FINAL ENVIRONMENTAL ASSESSMENT

***KAPIOLANI REGIONAL PARK  
MASTER PLAN UPDATE***

Waikiki, District of Honolulu, O'ahu, Hawai'i

April 2008

FIGURE 3  
MASTER PLAN

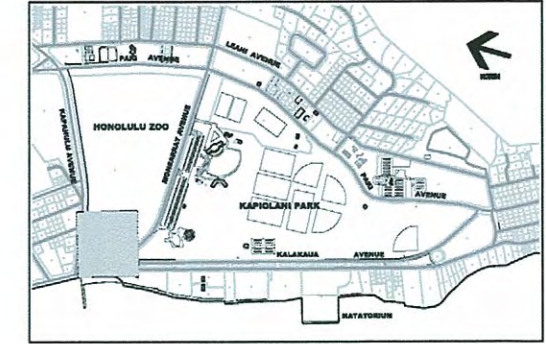
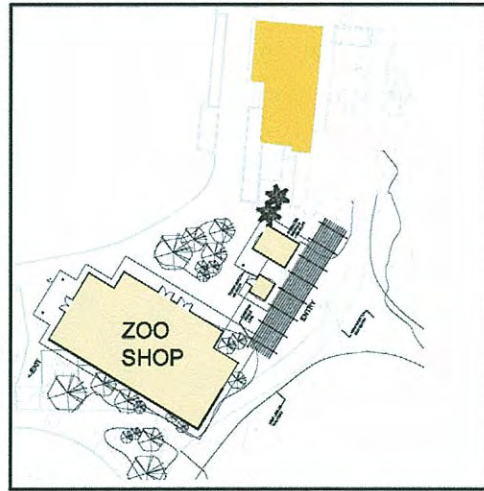
- Comments on figure 3:
  - Zoo entrance area - retain the Preis building, remove kiosk, add set back makai Monsarrat corner of zoo fence to permit views into the great Park open space from Kalakaua/Kapahu corner, as an exchange for the open space encroachment of the new zoo entrance into the Park's open space. (The set back of this corner of the fence has been approved by the Director of the Department of Enterprise Services.)

- Figure 3, titled "Kapiolani Regional Park" shows the trust boundaries and includes the Natatorium within the project. We believe that the DEA should include the plans for the Natatorium improvements. One of the reasons for this is to include future plans for parking. At a recent community meeting about the Natatorium the need for parking was discussed. To add more parking later while still being within the park's boundaries would be considered project segmentation. In order to do a complete

3. Figure 3, Master Plan, will be revised to show 12 rather than 11 Exceptional Trees. The Honolulu Zoo is not part of the Master Plan Update. The master plan does not affect any Exceptional Tree. However an Exceptional Tree Permit application process will be adhered to, should the need arise.

Four bicycle and moped parking areas are proposed. The location of the parking areas are shown in Figure 3 Master Plan.

Softball fields Nos. 1 and 3 will be adjusted several feet from their existing locations. The actual distance will be determined during the design stage. This is undertaken to accommodate portable backstops that will enhance public safety. The proposed adjustment of these fields is symbolically indicated on the Master Plan in Figure 3.

**FIGURE 4**  
**ZOO ENTRY IMPROVEMENTS**

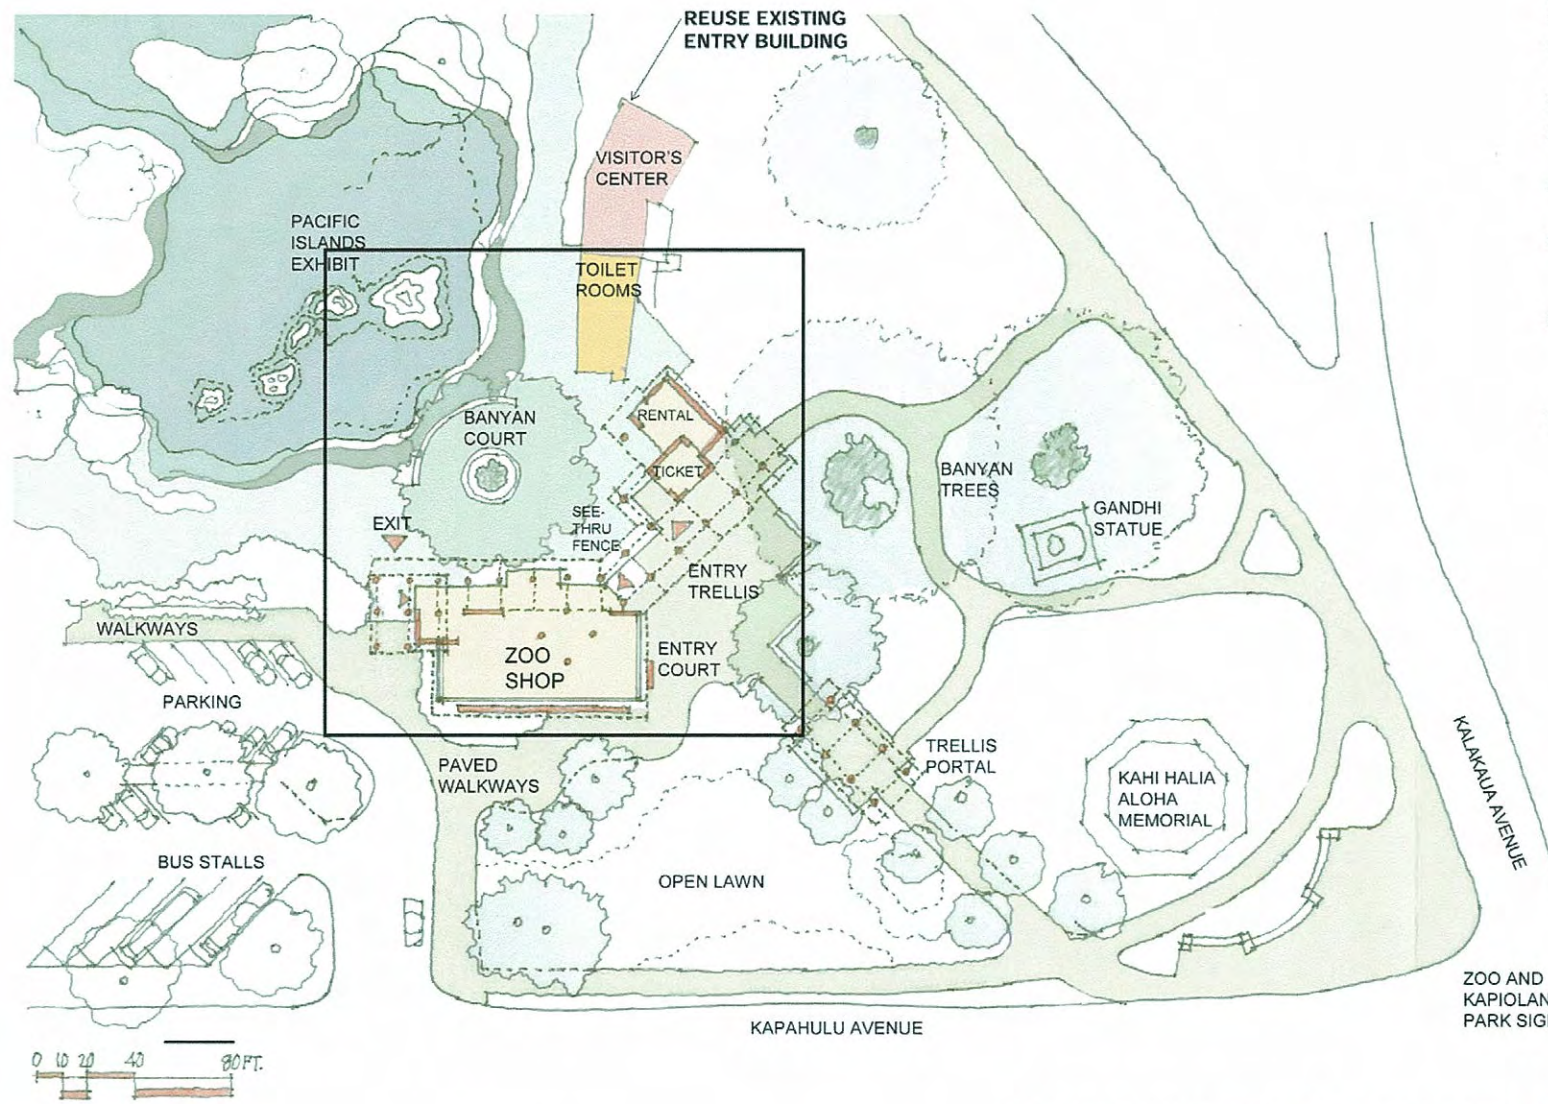
- Comments on figure 4:
  - The latest site plan is not shown. The plan shown is not acceptable as the zoo entrance intrudes too far into the Park. The revised plan (not

- a. What is the purpose of Figure 4?
  - b. What does "Zoo Entry - Typical Improvements", mean? Is this the Zoo Entry Improvement Plan for what is to be constructed or just a schematic drawing of what could be build?
  - c. If it is the Zoo Entry Plan then it must be more specific. If it is just a schematic drawing then it should be eliminated from the FEA.
3. The reasons given for the proposed improvements are the need for greater "visibility" and "accessibility" into the zoo.
- a. Was a needs assessment conducted to determine that the need for greater visibility and accessibility?
  - b. If an assessment was conducted the results should be included in the FEA?
  - c. If an assessment was not done explain how the conclusion was reached that these improvements are necessary.

Thus it goes without saying that the proposed storefront zoo entrance would be an abrupt intrusion into the historic landscape, as shown on Figure 4.<sup>27</sup> Further, in addition to being an exploitative encroachment into Kapiolani Park’s historic open space, the contemporary glass-wall architecture and two-story scale of this proposed expansion as presented to the public by the DDC is incongruous (i.e., out of place, odd, strange, bizarre, absurd, inappropriate, inconsistent, and incompatible) with the historic character of the Park. The present entrance was credibly and sensitively designed over forty-five years ago to unobtrusively fit within the historic landscape, and this compatibility should not be compromised in any way.

The FEAs will contain a revised Figure 4 with a plan for the new Zoo Entry showing the Zoo Shop orientation turned approximately 45 degrees and the fence line altered, as requested by the Director of the Department of Enterprise Services (DES).

The planned new Honolulu Zoo Entry is located on Kapiolani Park Trust lands as is the entire Zoo. The City has worked with community interest groups and individuals, and-most of them recognize the need for a new entrance and the challenges faced by the City. Some minor adjustments have been to the Park master plan at the Zoo entrance and are shown in Figure 4 of the Final Environmental Assessment (FEA).

Figure 5  
 Recreational Areas  
 Kapiolani Regional Park  
 Master Plan Update

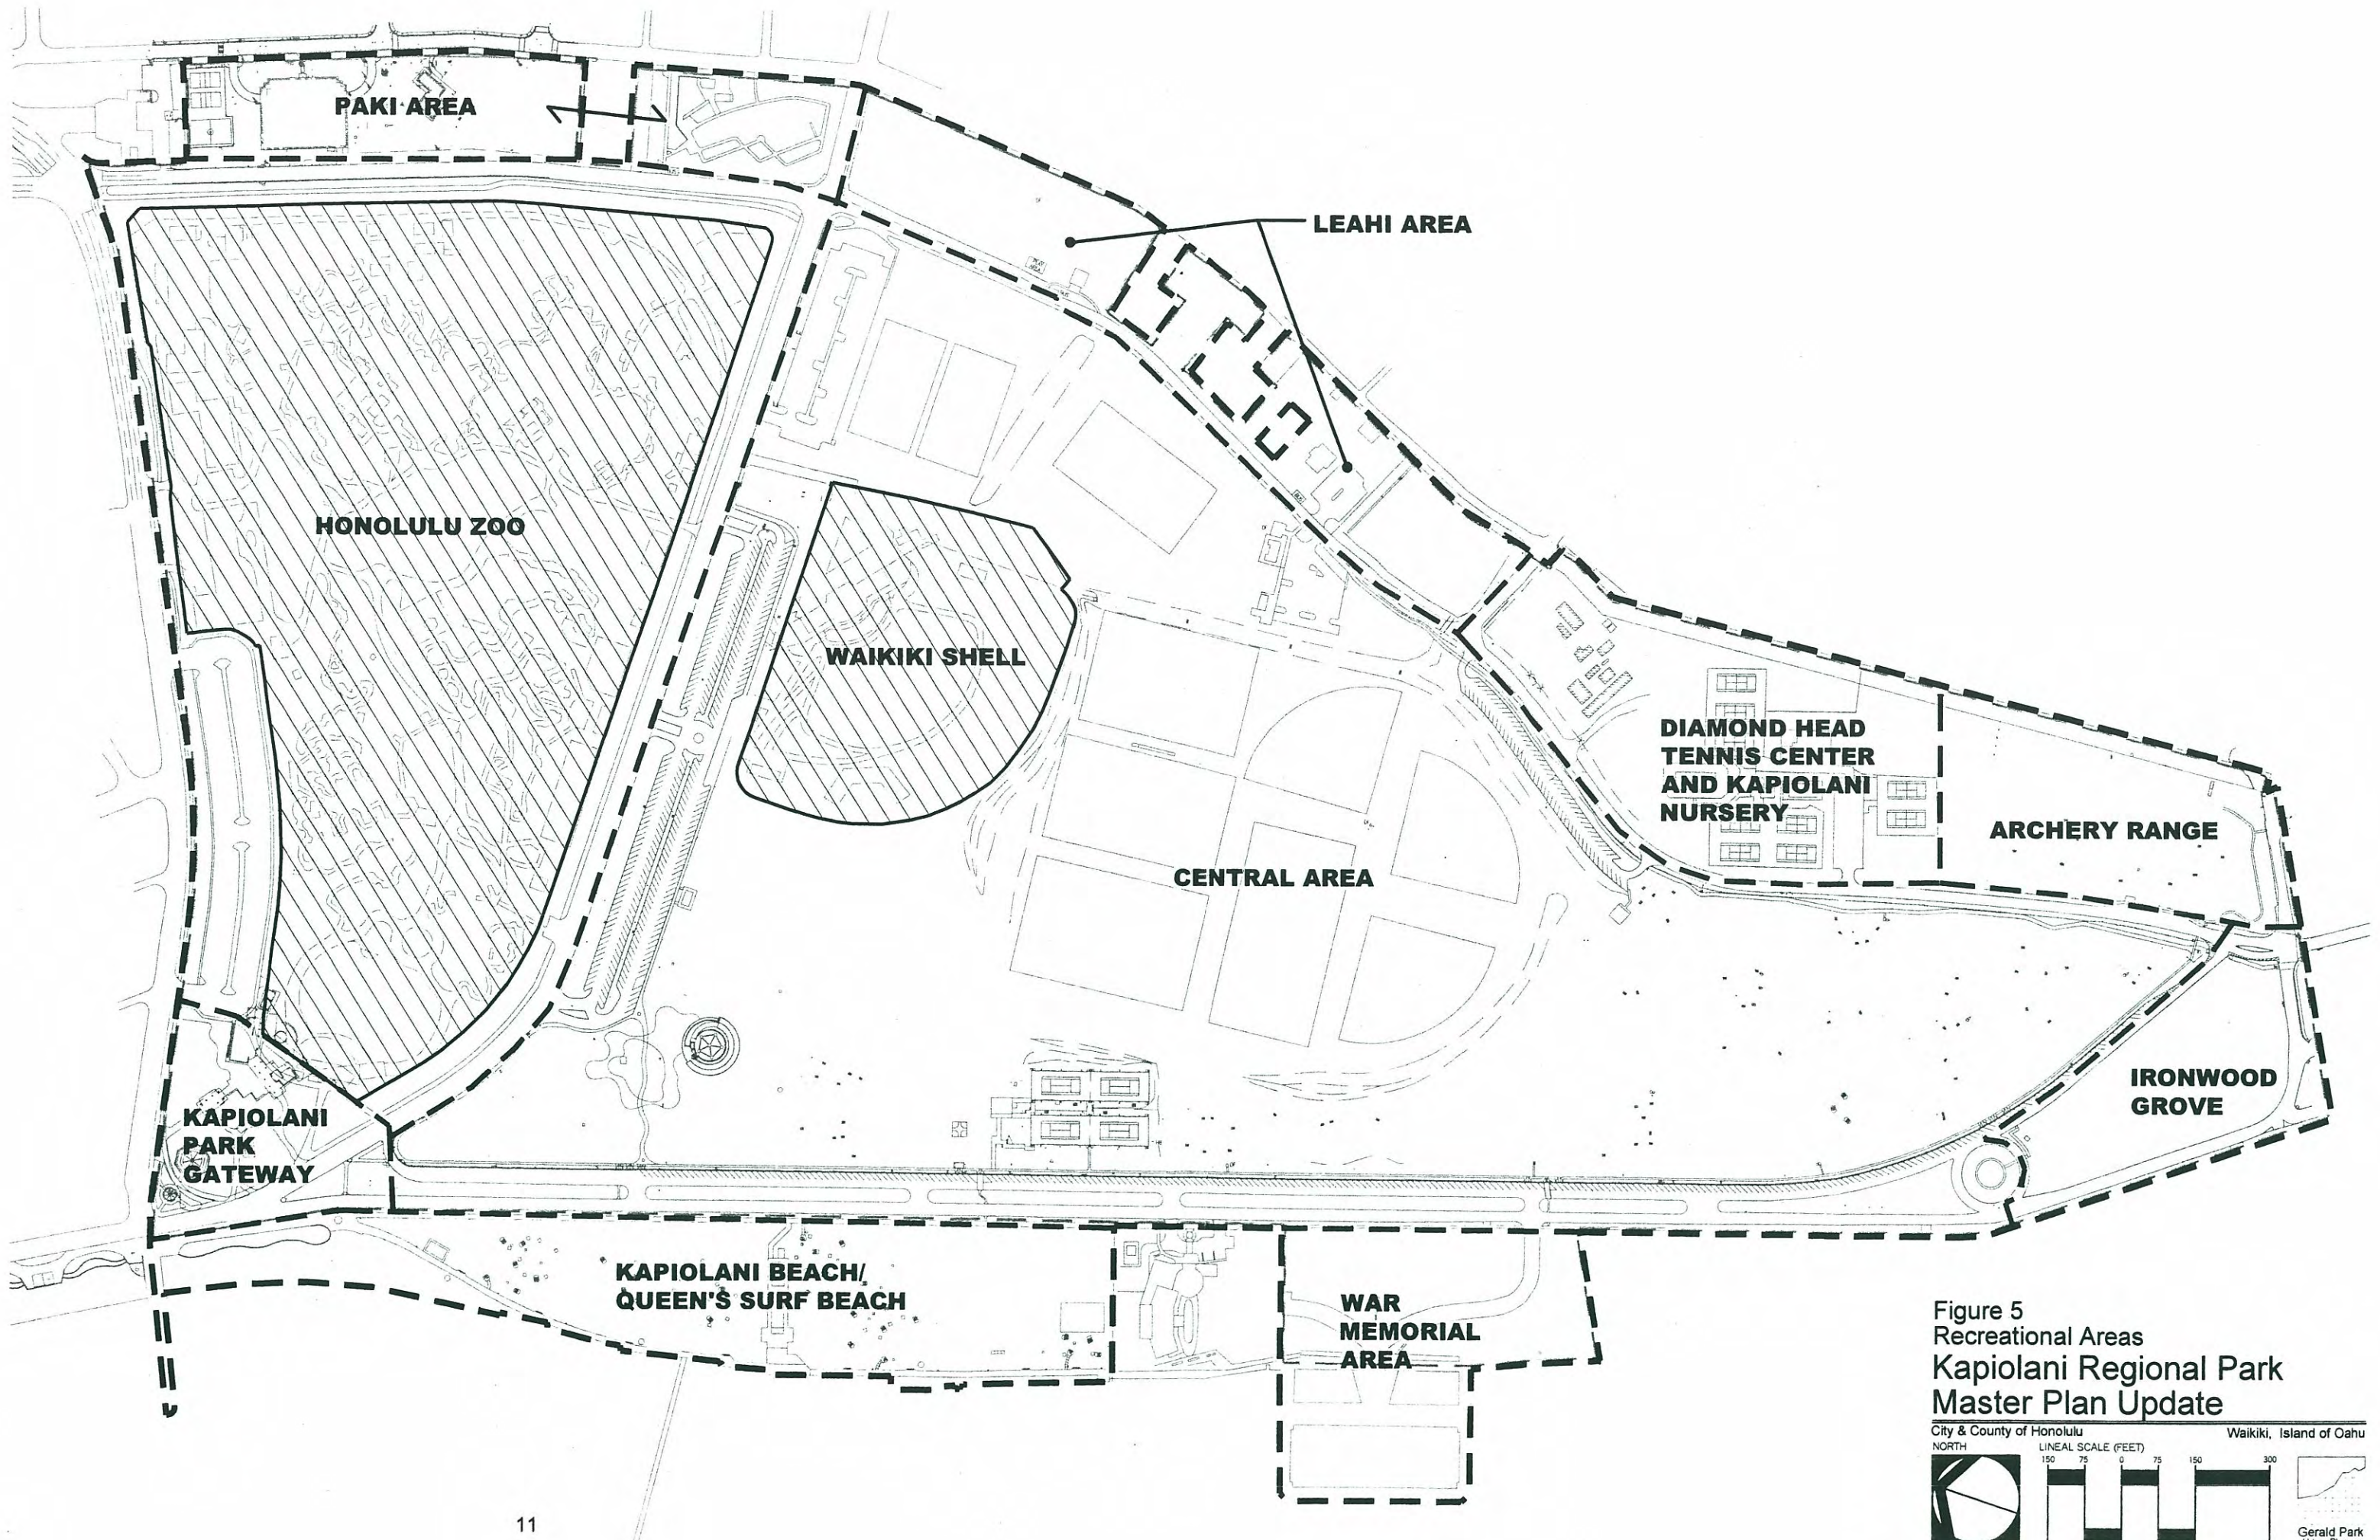
- Comments on figure 5:
  - This shows the archery range taking up a huge area when, in fact, its size is about 1/4 the area shown. The area is mostly a picnic area - and should be labeled as such - with a small area for archery. The archery use is potentially dangerous and **best relocated to a less-used park** elsewhere on the island. The **new Koko Head Crater range** is an excellent example of a proper location, and the City could be considering moving archery facilities for East Honolulu entirely to that location. Thus, archery should probably be eliminated from the long range master plan.

Your statement of opinion regarding the archery area is acknowledged. As indicated in the DEA (page 10), "The area references are intended only to facilitate an orderly description of the diverse areas making up the Park". Figure 5 graphically depicts the various areas described in the park including the existing archery range.

FIGURE 6  
**EXISTING CONDITIONS**

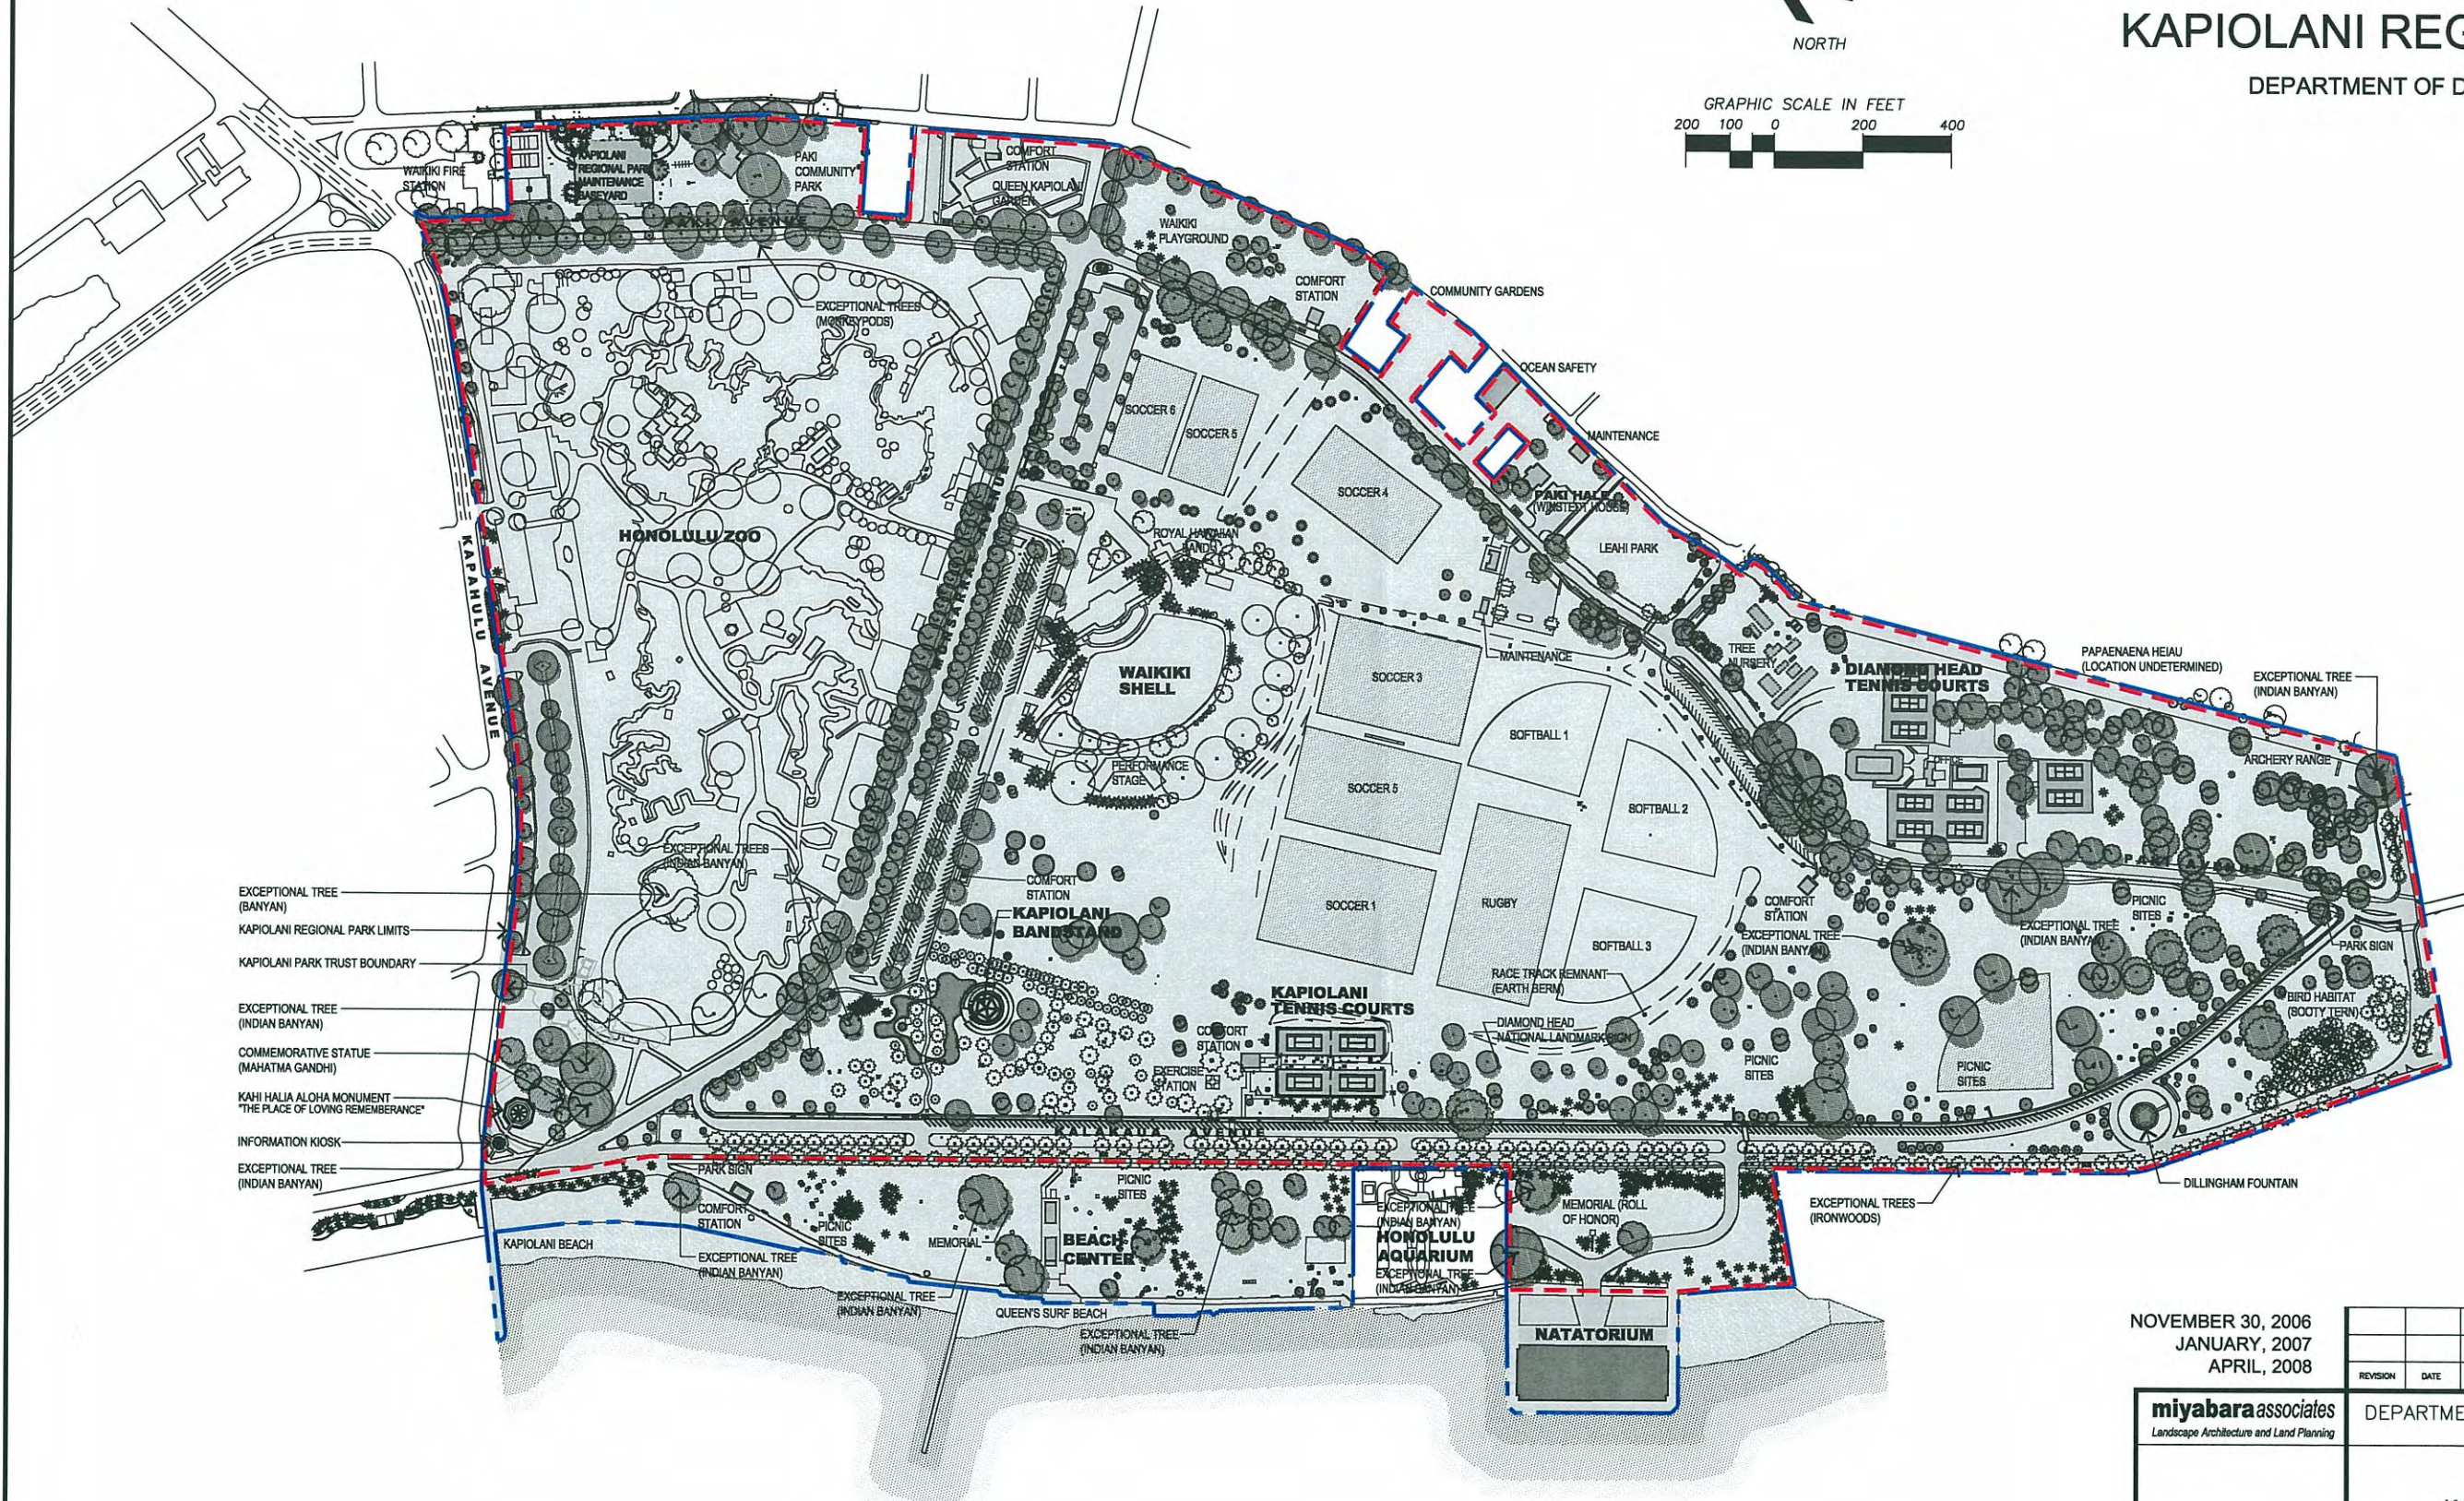
- Comments on figure 6:
  - The parking lot opposite Paki Hale looks like a mistake on the plan and it is! The lot should be removed.
  - P. 19: part H: Flora - there is no mention of one of the Park's oldest and most character-full trees - the kiawe. As **one of the original trees in the Park**, existing plantings of Kiawe need to be cared for and young thornless kiawe need to be added, particularly to dryer areas of the Park.

Figure 6 depicts existing conditions at the park. Please see our response to the comment to page 4:9 above.
